AMERICANS WITH DISABILITY
ACT (ADA) FACILITY
ASSESSMENT REPORT

Americans with Disabilities Act (ADA) Facility Barrier Report

July 2024

Rockwood Central Park

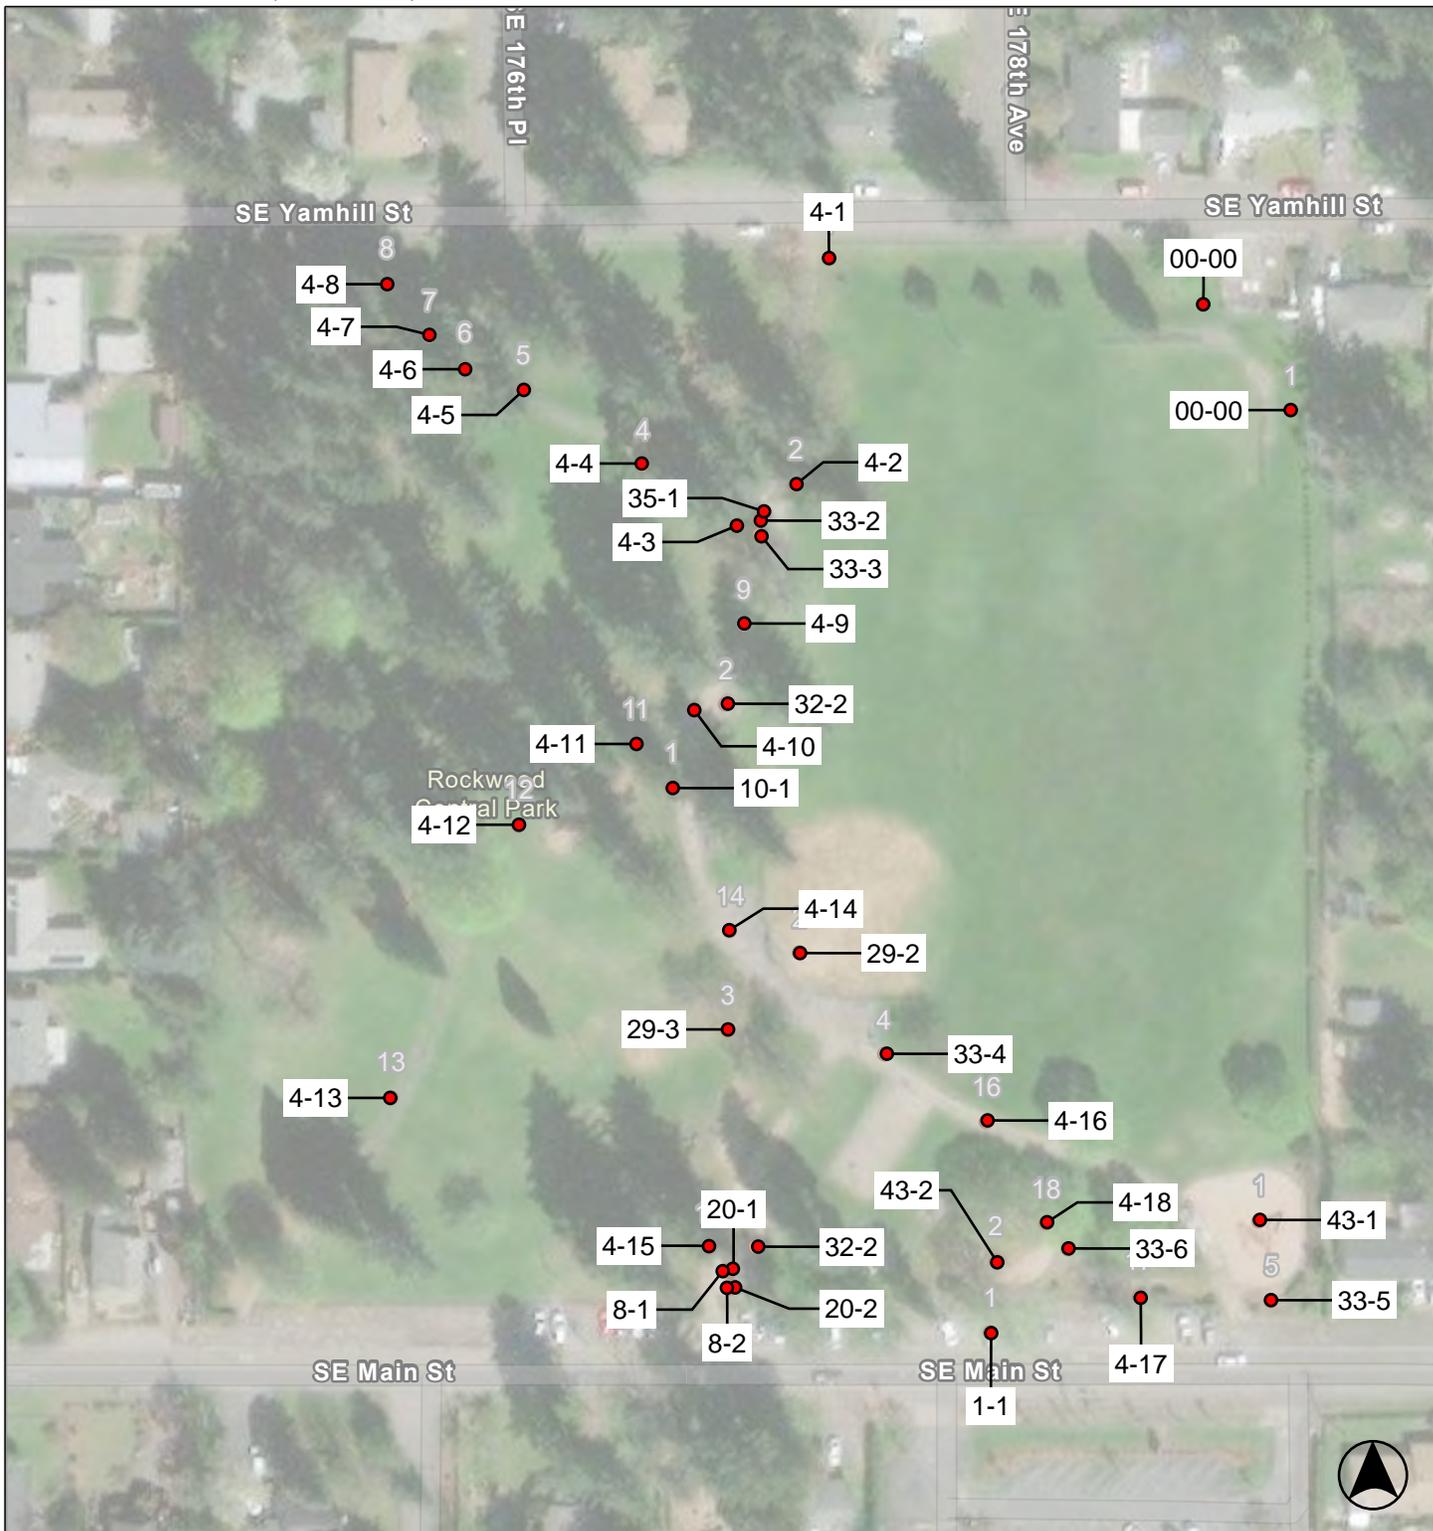
Park	
1 - 1	Parking Area Category: 1
Provide or modify accessible spaces	\$4,050
Notes: Parking lot with 54 total parking spaces of which zero are accessible parking spaces. Two additional spaces are needed (0 min space(S); 26 to 50 parking spaces).	
ADA: 208.2	
Other: OSSC 1106.1	
Provide a firm, stable and slip resistant surface	\$0
Notes: Parking space and access aisle is not firm and stable.	
ADA: 302.1, 502.4	
Other: -	
Provide adequate striping	\$180
Notes: A marked access aisle is not provided.	
ADA: -	
Other: OSSC 1106.7	
4 - 1	Walk Category: 1
Regrade surface	\$2,500
Notes: Running slope of concrete is up to 8.9% for 25 linear feet (5.0% max).	
ADA: 403.3	
Other: -	
Reduce or eliminate opening	\$300
Notes: Gap at concrete joint is greater than 1/2" (1/2" max).	
ADA: 302.3	
Other: -	
4 - 2	Walk Category: 1
Grind or patch vertical change of grade	\$100
Notes: Surface level change is 1/2" at concrete joint (1/4" max; up to 1/2" with a 1:2 bevel).

Park	
4 - 4	Walk Category: 1
Regrade surface	\$1,500
Notes: Running slope of concrete is up to 6.3% for 15 linear feet (5.0% max).	
ADA: 403.3	
Other: -	
Grind or patch vertical change of grade	\$100
Notes: Surface level change is greater than 1/4" at crack in concrete (1/4" max; up to 1/2" with a 1:2 bevel).	
ADA: 303.2, 303.3	
Other: -	
4 - 5	Walk Category: 1
Regrade surface	\$100
Notes: Running slope of concrete is up to 10.5% for 5 linear feet (5.0% max).	
ADA: 403.3	
Other: -	
Grind or patch vertical change of grade	\$100
Notes: Surface level change is greater than 1/4" at crack in concrete (1/4" max; up to 1/2" with a 1:2 bevel).	
ADA: 303.2, 303.3	
Other: -	
4 - 6	Walk Category: 1
Grind or patch vertical change of grade	\$100
Notes: Surface level change is 1/2" at crack in concrete (1/4" max; up to 1/2" with a 1:2 bevel).	
ADA: 303.2, 303.3	
Other: -	
4 - 7	Walk Category: 1
Regrade surface	\$300
Notes: Running slope of concrete is up to 5.9% for 3 linear feet (5.0% max).

ADA: 403.3	
Other: -	
Grind or patch vertical change of grade	\$100
Notes: Surface level change is 1/2" at crack in concrete (1/4" max; up to 1/2" with a 1:2 bevel). (x2)	
ADA: 303.2, 303.3	
Other: -

Park	
4 - 8	Walk Category: 1
Grind or patch vertical change of grade	\$100
Notes: Surface level change is 1" at crack in concrete (1/4" max; up to 1/2" with a 1:2 bevel).	
ADA: 303.2, 303.3	
Other: -	
4 - 9	Walk Category: 1
Grind or patch vertical change of grade	\$100
Notes: Surface level change is 1/2" at concrete joint (1/4" max; up to 1/2" with a 1:2 bevel).	
ADA: 303.2, 303.3	
Other: -	
Regrade surface	\$2,800
Notes: Cross slope of concrete is up to 5.1% for 28 linear feet (2.0% max).	
ADA: 403.3	
Other: -	
4 - 10	Walk Category: 1
Regrade surface	\$400
Notes: Cross slope of concrete is up to 2.6% for 4 linear feet (2.0% max).	
ADA: 403.3	
Other: -	
4 - 11	Walk Category: 1
Regrade surface	\$2,200
Notes: Cross slope of concrete is up to 3.6% for 22 linear feet (2.0% max).	
ADA: 403.3	
Other: -	
Reduce or eliminate opening	\$300
Notes: Gap at concrete joint is greater than 1/2" (1/2" max).	
ADA: 302.3	
Other: -

Park	
4 - 12	Walk Category: 1
Regrade surface	\$4,600
Notes: Running slope of concrete is up to 8.6% (5.0% max) and cross slope is up to 3.6% (2.0% max) for 46 linear feet.	
ADA: 403.3	
Other: -	
Grind or patch vertical change of grade	\$100
Notes: Surface level change is greater than 1/2" at concrete joint (1/4" max; up to 1/2" with a 1:2 bevel).	
ADA: 303.2, 303.3	
Other: -	
4 - 13	Walk Category: 1
Grind or patch vertical change of grade	\$100
Notes: Surface level change is 1" at crack in concrete (1/4" max; up to 1/2" with a 1:2 bevel).	
ADA: 303.2, 303.3	
Other: -	
4 - 14	Walk Category: 1
Regrade surface	\$12,200
Notes: Cross slope of concrete is up to 4.1% for 122 linear feet (2.0% max).	
ADA: 403.3	
Other: -	
4 - 15	Walk Category: 1
Regrade surface	\$5,100
Notes: Cross slope of concrete is up to 3.6% for 51 linear feet (2.0% max).	
ADA: 403.3	
Other: -	
Grind or patch vertical change of grade	\$100
Notes: Surface level change is greater than 1/4" at concrete joint (1/4" max; up to 1/2" with a 1:2 bevel).

Park	
4 - 17	Walk Category: 1
Regrade surface	\$2,200
Notes: Cross slope of concrete is up to 3.6% for 22 linear feet (2.0% max).	
ADA: 403.3	
Other: -	
Grind or patch vertical change of grade	\$100
Notes: Surface level change is 1/2" at concrete joint (1/4" max; up to 1/2" with a 1:2 bevel).	
ADA: 303.2, 303.3	
Other: -	
4 - 18	Walk Category: 1
Grind or patch vertical change of grade	\$100
Notes: Surface level change is 1" at concrete joint (1/4" max; up to 1/2" with a 1:2 bevel).	
ADA: 303.2, 303.3	
Other: -	
8 - 1	Door/Gate Category: 1
Adjust door closer	\$160
Notes: Door opening force is 7 lbs (5 lbs max).	
ADA: 404.2.9	
Other: OSSC 1102.1.2.5	
Regrade surface	\$625
Notes: Slope of the exterior landing is 3.6% (2.0% max).	
ADA: 404.2.4.4	
Other: -	
8 - 2	Door/Gate Category: 1
Regrade surface	\$625
Notes: Slope of the exterior landing is 3.7% (2.0% max).	
ADA: 404.2.4.4	
Other: -	
Replace door hardware	\$550
Notes: Door hardware is jammed; door was not operable at time of assessment.

Park	
10 - 1 Drinking Fountain	Category: 3
Confirm water flow compliance	\$0
Notes: Water service to the drinking fountain was disconnected at the time of the assessment. Flow height and angle could not be confirmed.	
ADA: 602.3, 602.6	
Other: -	
20 - 1 Single User Restroom	Category: 2
Install restroom sign	\$250
Notes: Replace sign. Sign contains hole and cracks that could cause injury. Letters are not tactile, braille is not provided beneath text.	
ADA: 216.8	
Other: -	
Replace or reposition fixtures	\$1,590
Notes: The water closet centerline is 18-1/2" from the wall (16" min to 18" max).	
ADA: 604.2	
Other: -	
Replace or reposition dispenser	\$160
Notes: The centerline of the toilet paper in front of the water closet is 12" (7" min and 9" max).	
ADA: 604.7	
Other: -	
Replace or adjust water controls	\$640
Notes: Water flow was not operational on the day of assessment	
ADA: 309.4, 606.4	
Other: -

Park	
20 - 2	Single User Restroom Category: 2
Install restroom sign	\$250
Notes: Replace sign. Broken edges could cause injury. Letters are not tactile, braille is not provided beneath text.	
ADA: 216.8	
Other: -	
Replace or reposition fixtures	\$1,590
Notes: The water closet centerline is 18-1/2" from the wall (16" min to 18" max).	
ADA: 604.2	
Other: -	
Replace or reposition dispenser	\$160
Notes: The centerline of the toilet paper in front of the water closet is 12" (7" min and 9" max).	
ADA: 604.7	
Other: -	
Replace or adjust water controls	\$640
Notes: Water flow was not operational on the day of assessment	
ADA: 309.4, 606.4	
Other: -	
29 - 1	Game and Sports Area Category: 2
Provide an accessible route	\$16,560
Notes: An accessible route to the baseball backstop is not provided. Route from the nearest path to the backstop is 207 linear feet over grass. Route from the public right-of-way is 85 linear feet over grass.

ADA: 206.2.2	
Other: -	
Enlarge accessible route	\$190
Notes: Clear width of the route to the player seating is 30 inches due to overgrown grass. (36" min wide).	
ADA: 404.2.3	
Other: -	
Provide wheelchair seating	\$1,800
Notes: Debris in the wheelchair space for players.	
ADA: 802.1	
Other: -

Park	
29 - 2	Game and Sports Area Category: 2
Provide companion seating	\$1,780
Notes: Cross slopes in team wheelchair spaces are between 4.2 - 6.2% (2.0% max). (x2)	
ADA: 221.3, 802.3.1, 802.3.2	
Other: -	
29 - 3	Game and Sports Area Category: 2
Provide an accessible route	\$8,000
Notes: Multiple disc golf launch pads are not connected via an accessible route. Estimated total length of missing routes is 100 ft.	
ADA: 206.2.2	
Other: -	
32 - 1	Picnic Area Category: 2
Provide an accessible table	\$3,250
Notes: Knee clearance measured 8" horizontally from the front face of the table top is 24" (27" min).	
ADA: -	
Other: ABA 306.3	
32 - 2	Picnic Area Category: 2
Provide an accessible table	\$3,250
Notes: Knee clearance measured 8" horizontally from the front face of the table top is 24-1/2" (27" min).	
ADA: -	
Other: ABA 306.3	
Reduce or eliminate opening	\$300
Notes: The picnic area has 1-1/2" openings at gap between the path and picnic area (1/2" max).

Park	
32 - 3 Picnic Area	Category: 2
Increase or provide clear floor area	\$200
Notes: The clear space around the picnic table narrows down to 24" (36" min wide).	
ADA: -	
Other: ABA 1011.2.1	
Provide an accessible picnic unit	\$4,060
Notes: The picnic facility provides four picnic units and one are designed for accessibility (20% min but not less than two picnic units are required to be accessible). At least two accessible picnic units are required.	
ADA: -	
Other: ABA F245.2.2	
33 - 1 Outdoor Constructed Features	Category: 3
Increase or provide clear floor area	\$200
Notes: A clear floor space is not provided at the trash container opening (36" by 60" min parallel approach or 36" by 48" min forward approach).	
ADA: -	
Other: ABA 1011.2	
33 - 2 Outdoor Constructed Features	Category: 3
Increase or provide clear floor area	\$200
Notes: Clear floor space at the trash container opening has a 2" change of level and gaps greater than a 1/2" (36" by 60" min parallel approach or 36" by 48" min forward approach).

ADA: -	
Other: ABA 1011.2	
33 - 3 Outdoor Constructed Features	Category: 3
Increase or provide clear floor area	\$200
Notes: The clear ground space adjacent to the bench is 30" deep (36" by 48" min).	
ADA: -	
Other: ABA 1011.2.1, ABA 1011.2.3	
33 - 4 Outdoor Constructed Features	Category: 3
Increase or provide clear floor area	\$200
Notes: The clear floor space for the trash container has a cross slope of 3.8% (2.0% max).	
ADA: -	
Other: ABA 1011.2

Park	
33 - 5	Outdoor Constructed Features Category: 3
Provide an accessible route	\$1,200
Notes: An accessible route to the fixed bench is not provided. Route is 15 linear feet over woodchips from curb to bench.	
ADA: -	
Other: ABA F206.2.2	
33 - 6	Outdoor Constructed Features Category: 3
Increase or provide clear floor area	\$200
Notes: A clear ground space is not provided adjacent to the bench (36" by 48" min). Companion space overlaps with the path of travel.	
ADA: -	
Other: ABA 1011.2.1, ABA 1011.2.3	
35 - 1	Other Category: 3
Reposition controls	\$285
Notes: Operating mechanism of dog bag station is 65" above the ground (15" min to 48" max).	
ADA: 308.2, 308.2.1	
Other: -	
Increase or provide maneuvering or clear floor area	\$200
Notes: Clear floor space of the dog bag station contains an elevation change of 1/2" (1/4" max).	
ADA: 305.2, 305.3, 305.5	
Other: -	
43 - 1	Play Equipment Area Category: 2
Improve or evaluate play area surface	\$0

Notes: Ground surface in play area is in need of maintenance and further evaluation of fall attenuation surface is recommended.	
ADA: 1008.2.6.1, 1008.2.6.2	
Other: -	
Provide play components	\$19,050
Notes: The play area has 9 elevated play components of 3 different types, with 0 ground components (for 8 to 10 elevated play components, 3 min ground components of 3 different types are required).	
ADA: 1008.2.1, 240.2.1.2	
Other: -
